The text reproduced below reflects the state of play of the discussion of the SIG UNR157 up to its 7th meeting on raising the specified maximum speed of ALKS up to 130 km/h. It is based on ECE/TRANS/WP.29/GRVA/2020/32 (DE) and subsequent amendments received on this proposal.

Modifications to the existing text of UN-Regulation No. 157 (incl. suppl. 02 to 00 series) are marked in **black bold** for new or ~~strikethrough~~ for deleted characters.

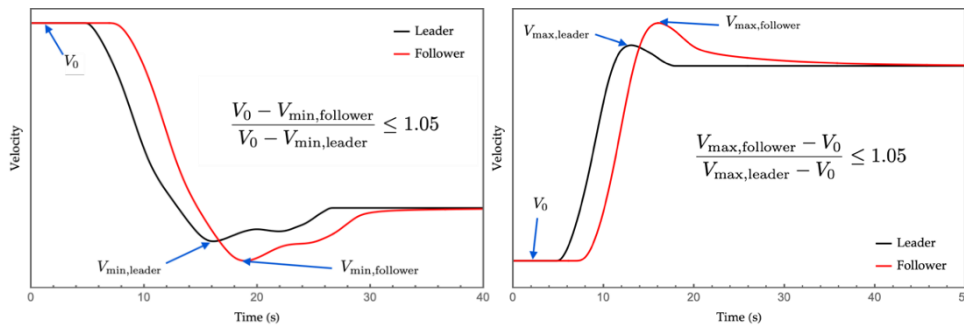
Group conclusion: Delete proposed new para. 5.2.9 and 5.2.10.

Figure 1

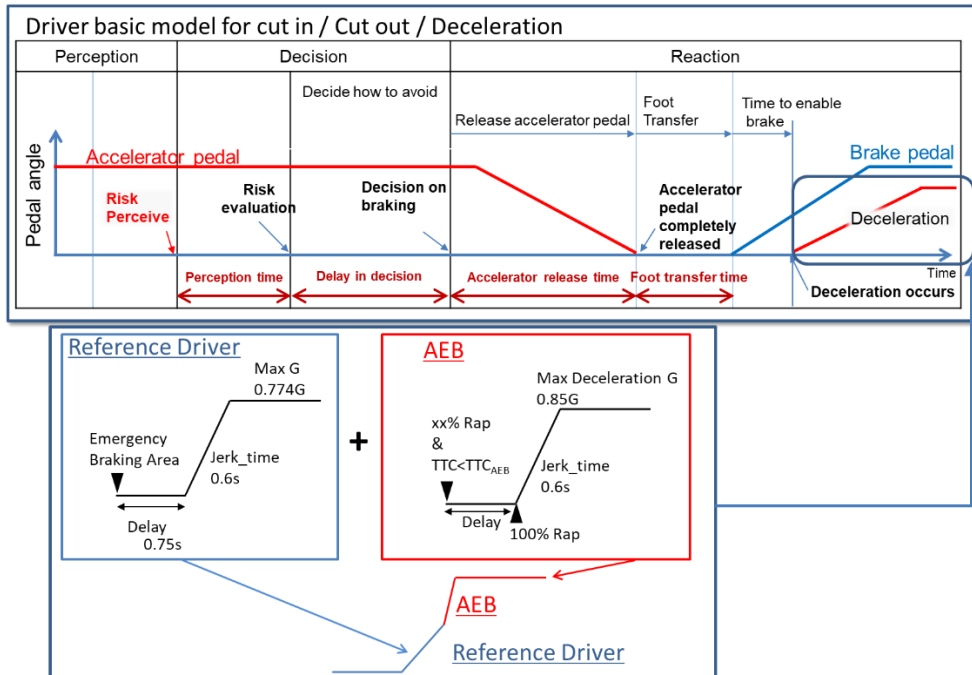
Group conclusion: agreed to amend title of figure accordingly:

~~Skilled Careful~~ **Competent and competent careful** human performance model
